EARLY DESIGN GUIDANCE

9201 Delridge Way SW
Seattle, WA

SDCI PROJECT NO.:
3029353

MEETING DATE:
12/28/17

DESIGN ANALYSIS

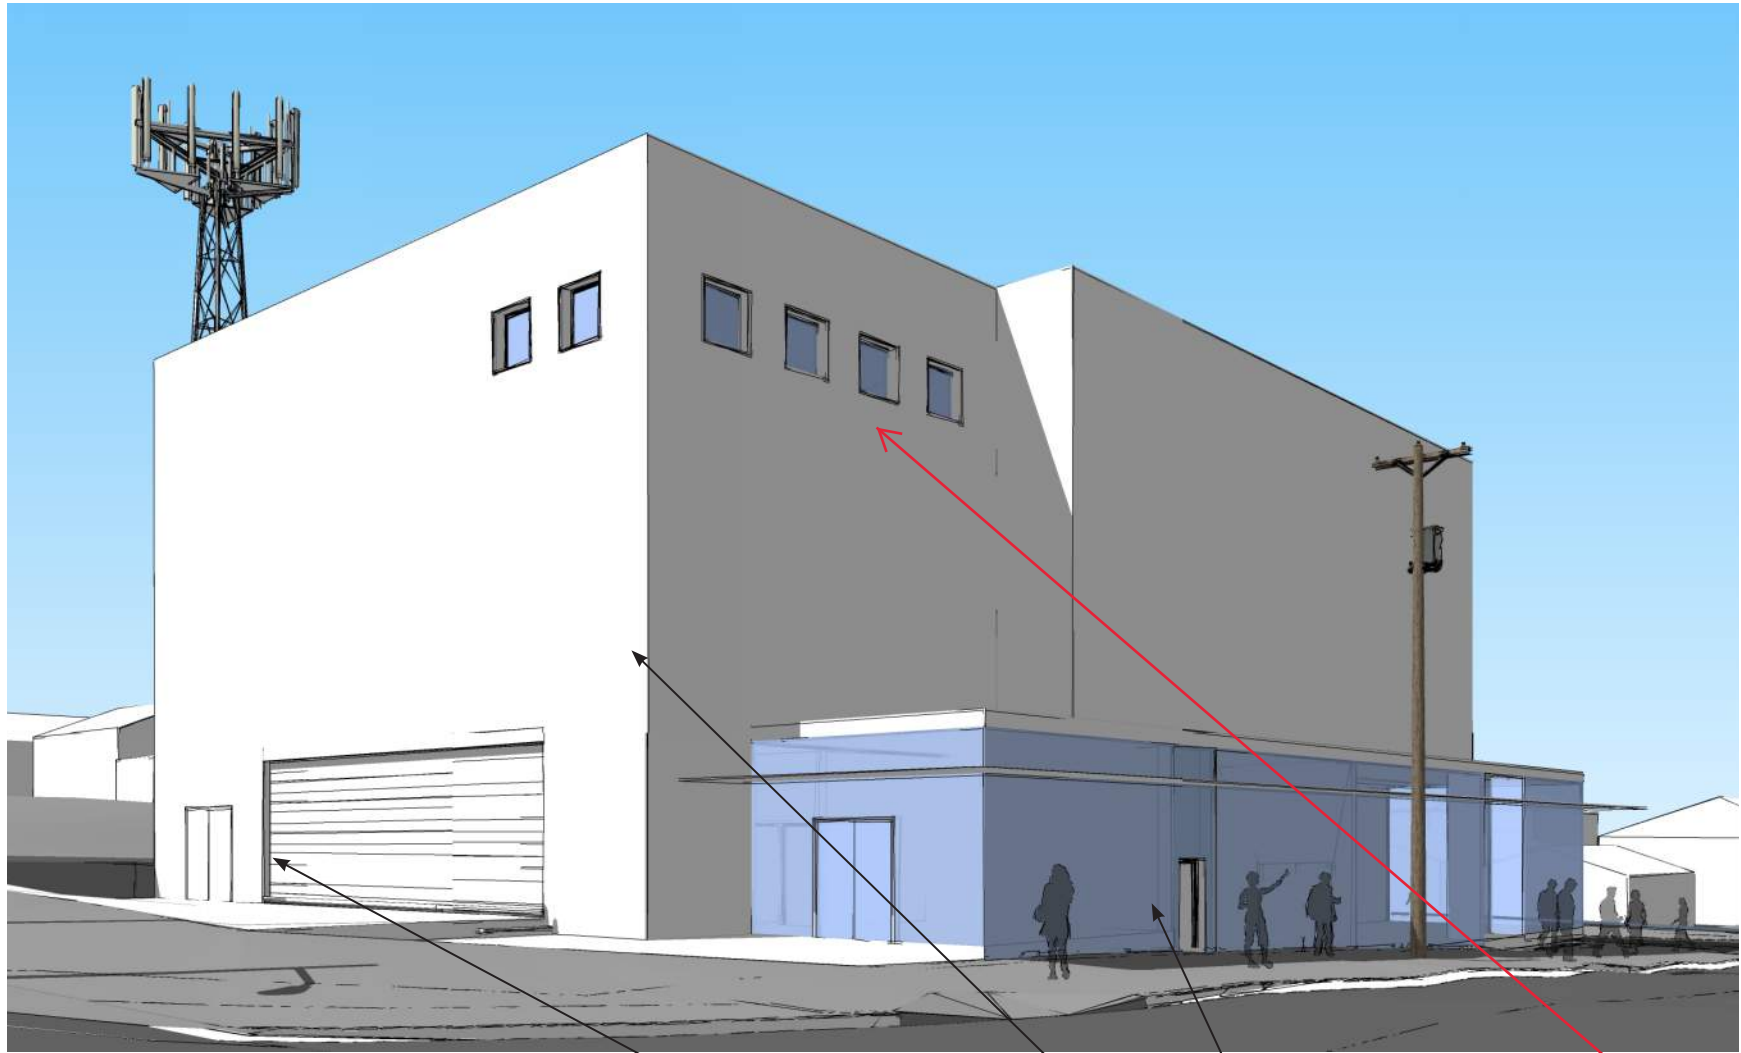
this appears to be the caretaker unit.

this doesnt match the floor plans.

8.0 PREFERRED OPTION 3 | FLOOR PLANS

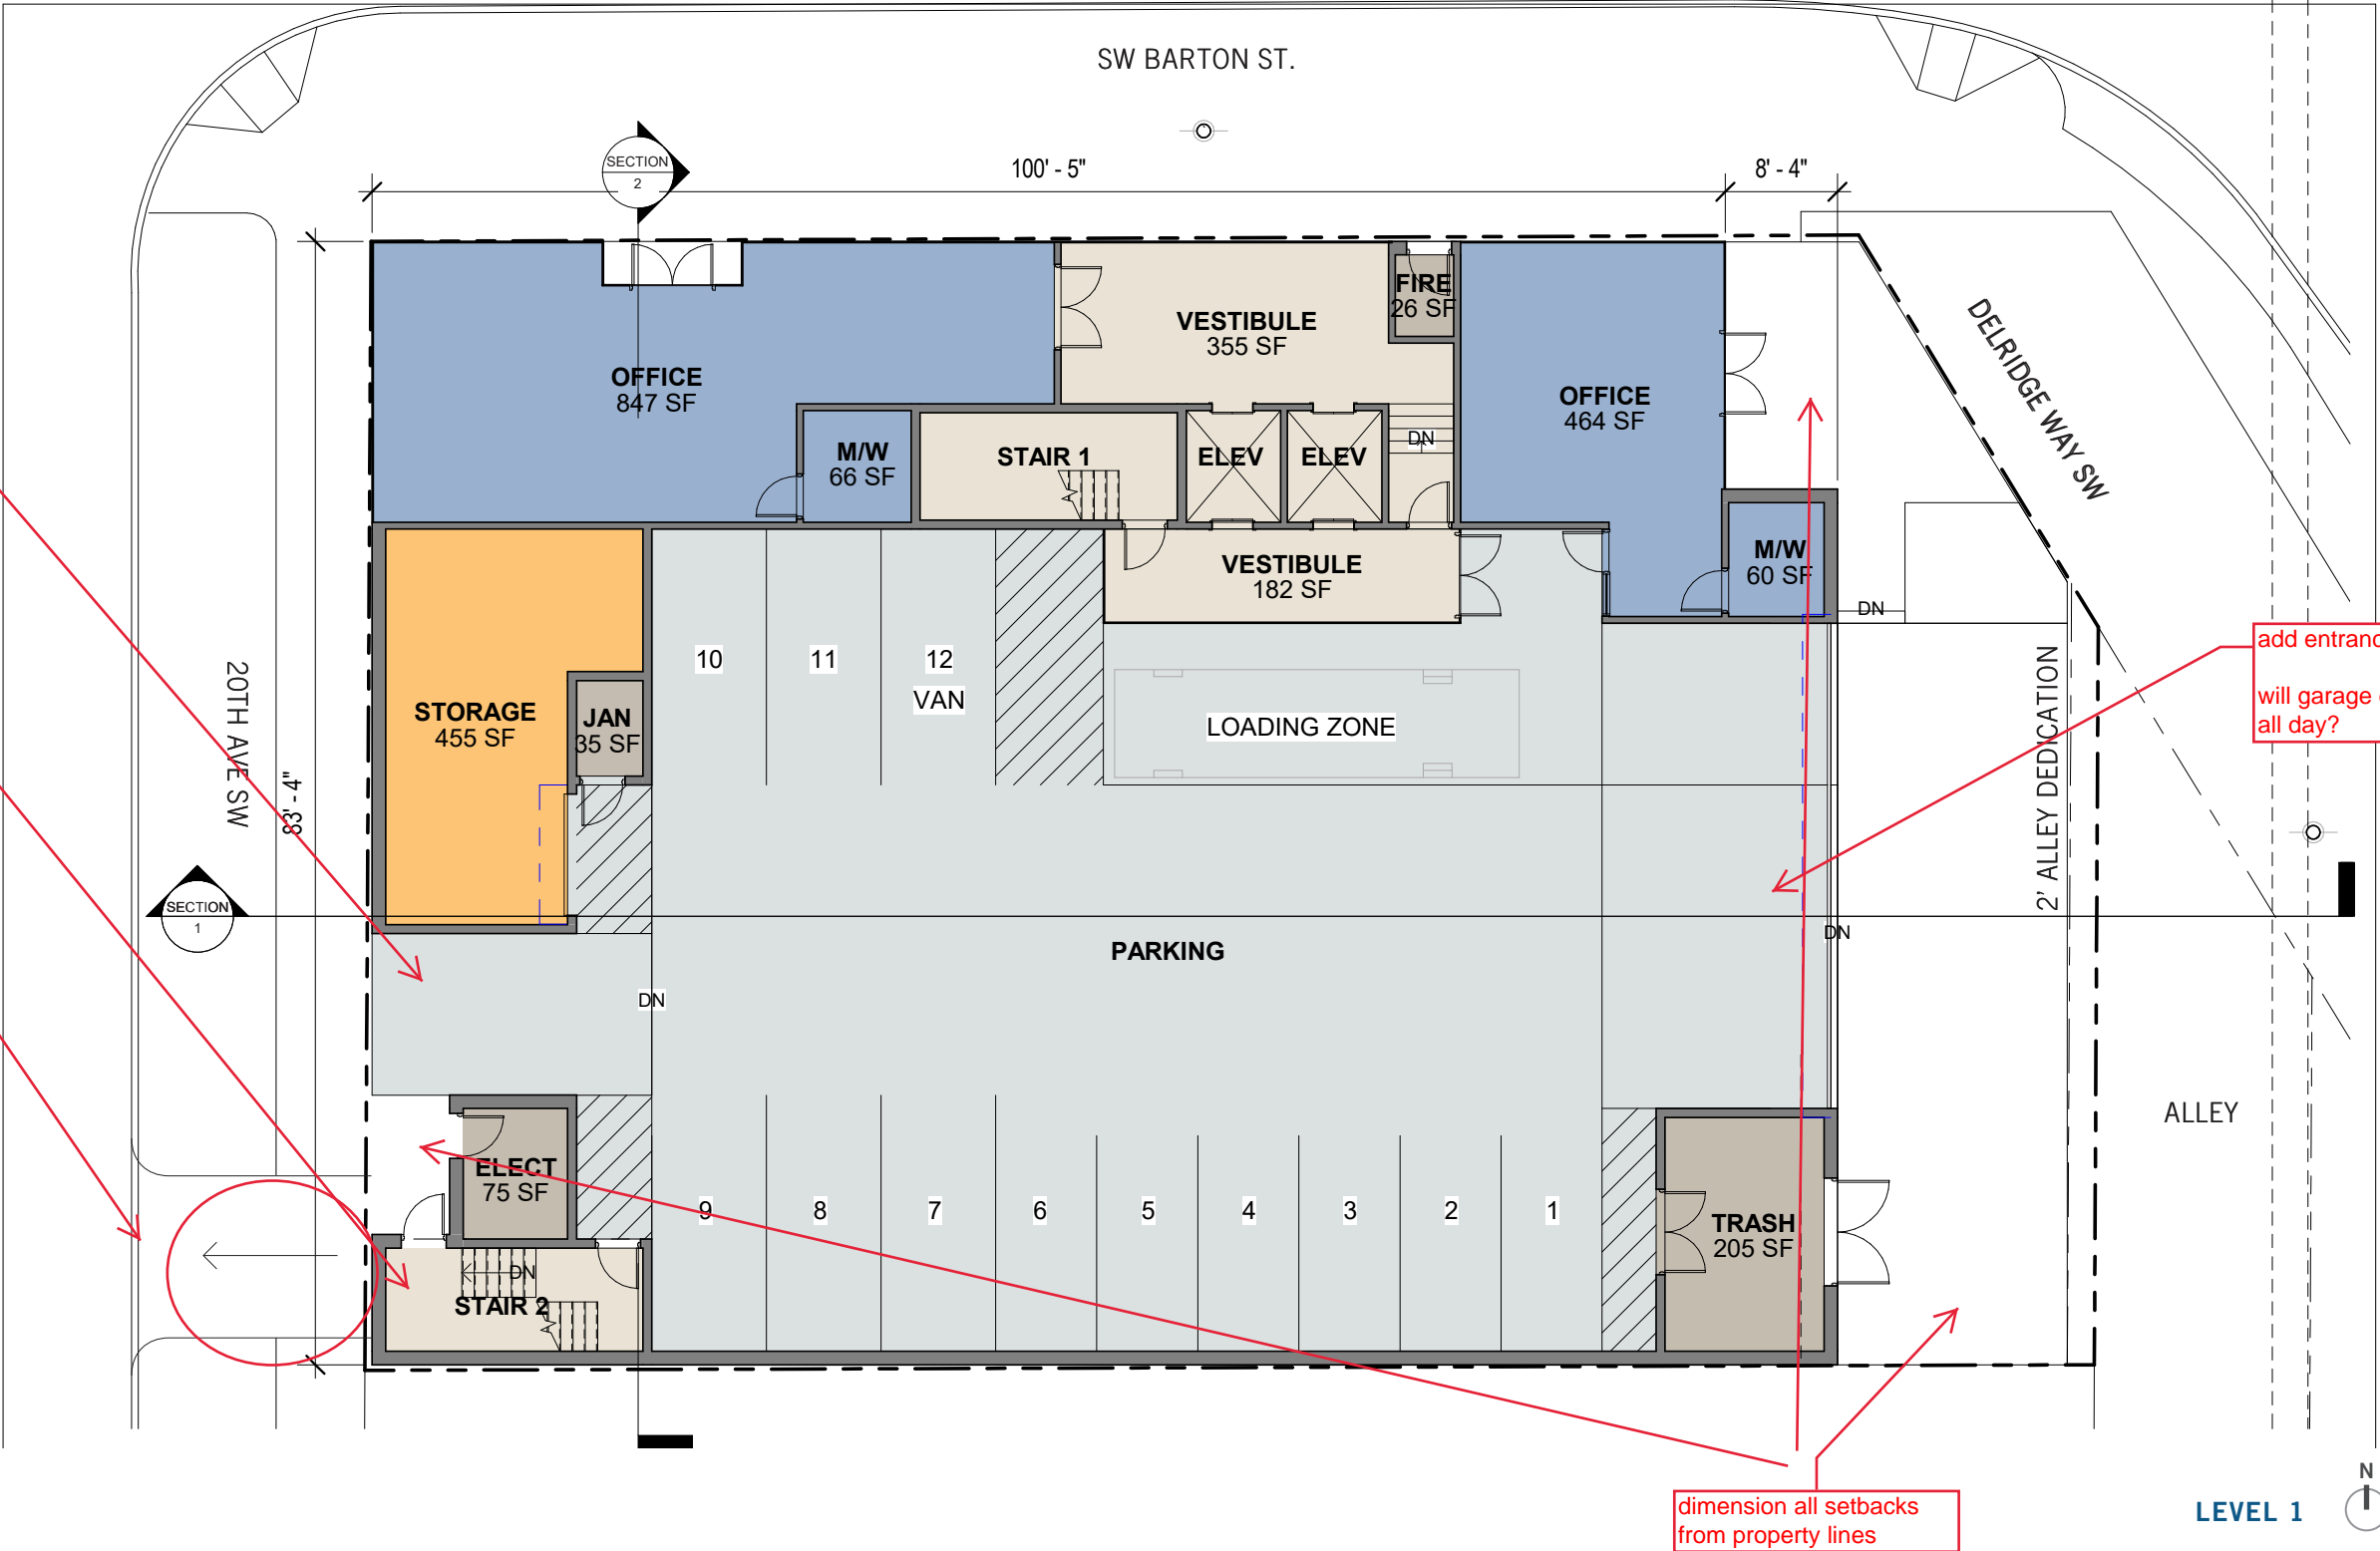
How does the massing act as wayfinding for vehicles to the garage entrance?

is this exit is for large trucks only, will signage be provided in the garage?

stair tower is shown highly glazed, revise line to reflect this glazing

move arrow and curb cut to match exit

add entrance/exit arrows.
will garage door be open all day?

dimension all setbacks from property lines

9.0 OPTION 1 DEPARTURE

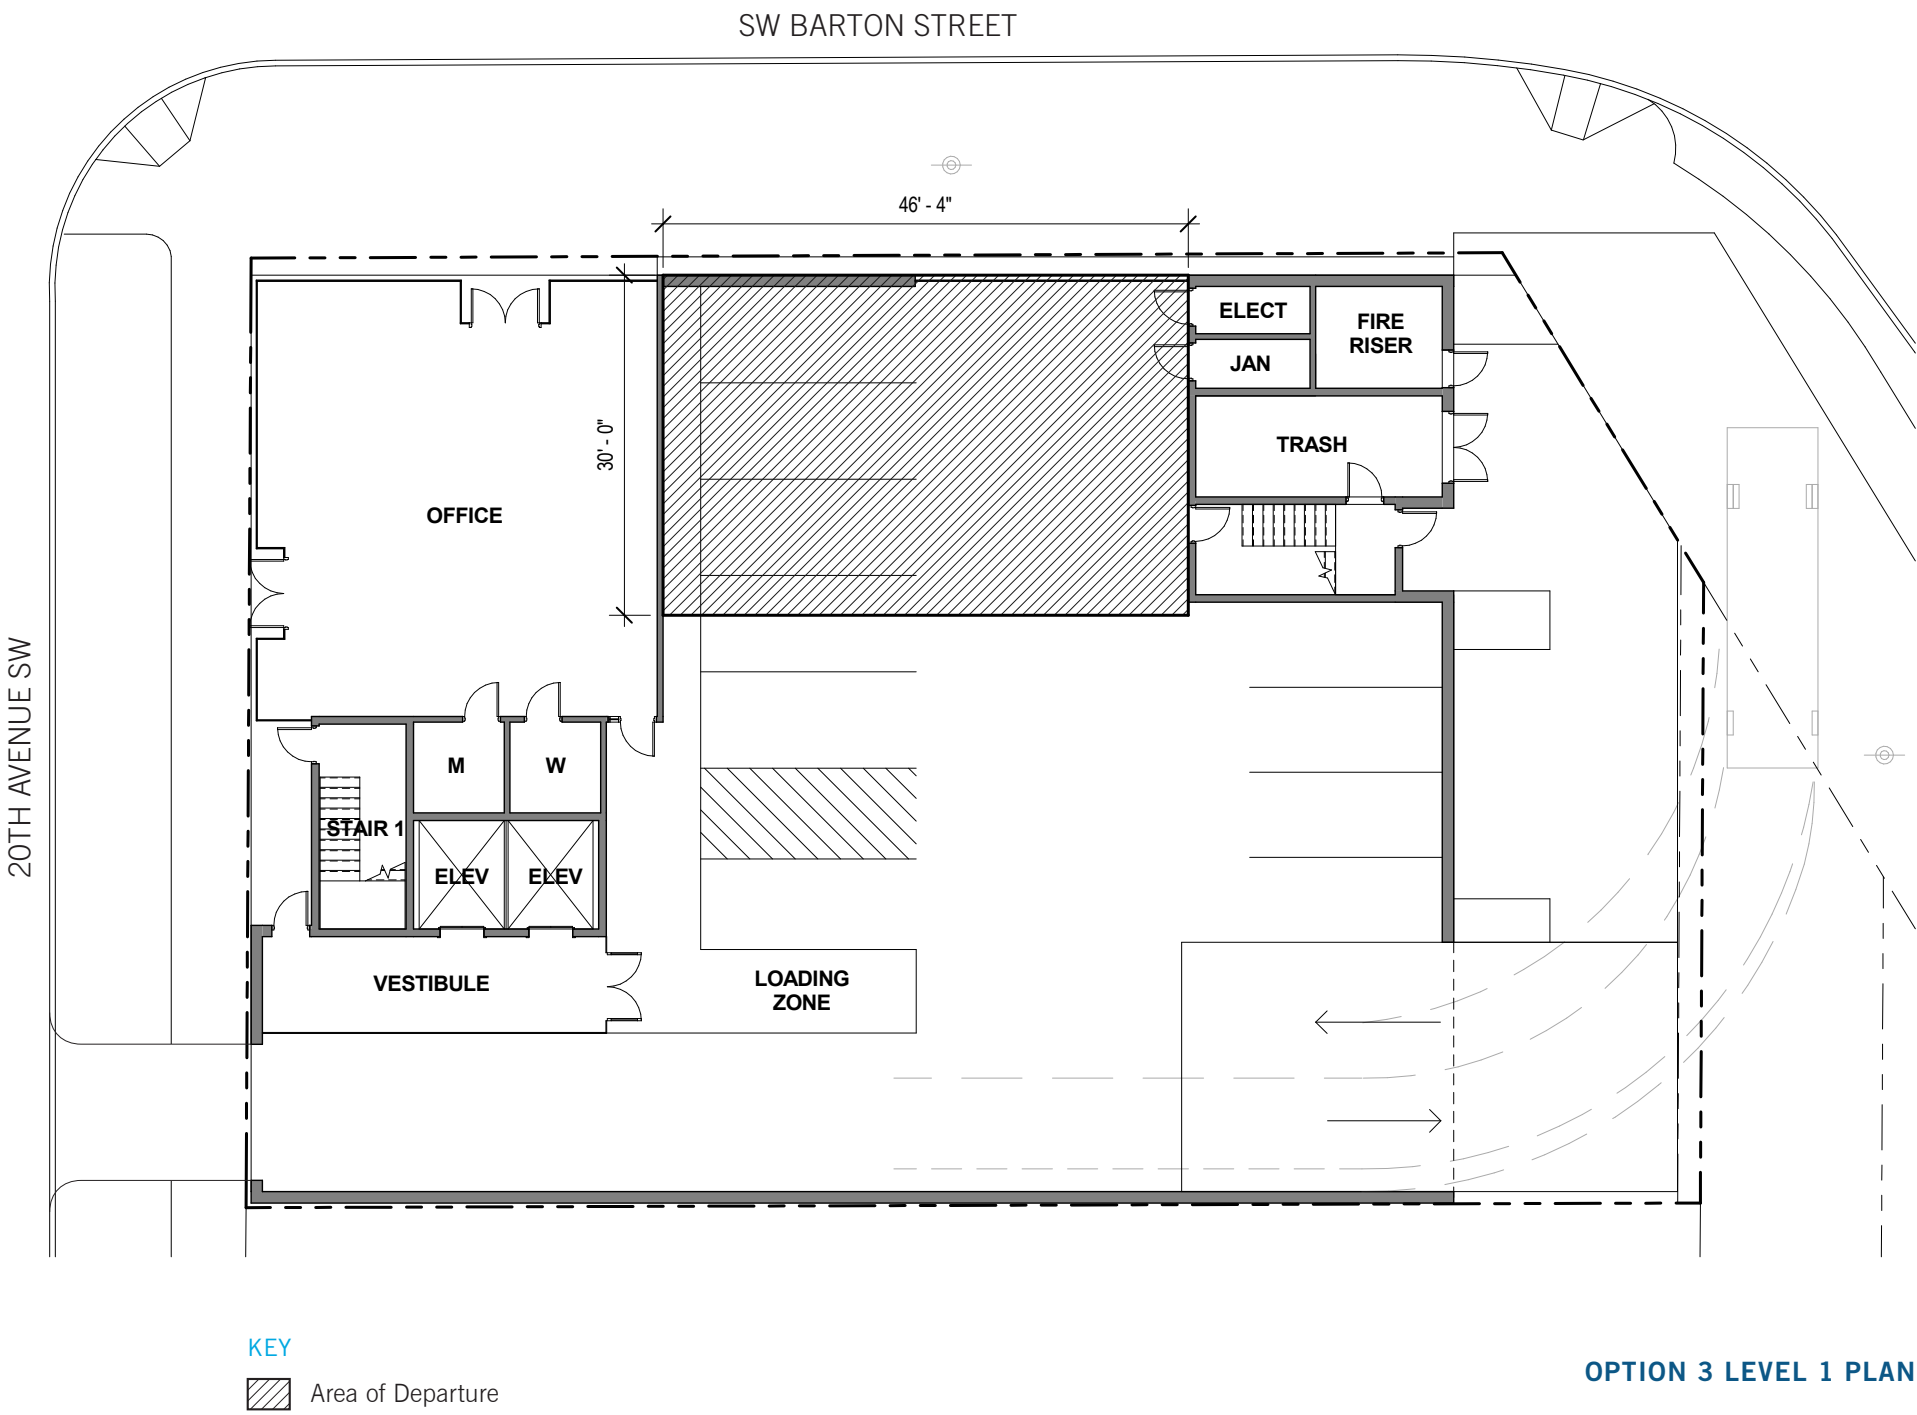
add a bit more description of how this design better meets the intent of the selected design guideline - and identify which guidelines specifically is better met - not just the DC1 section.
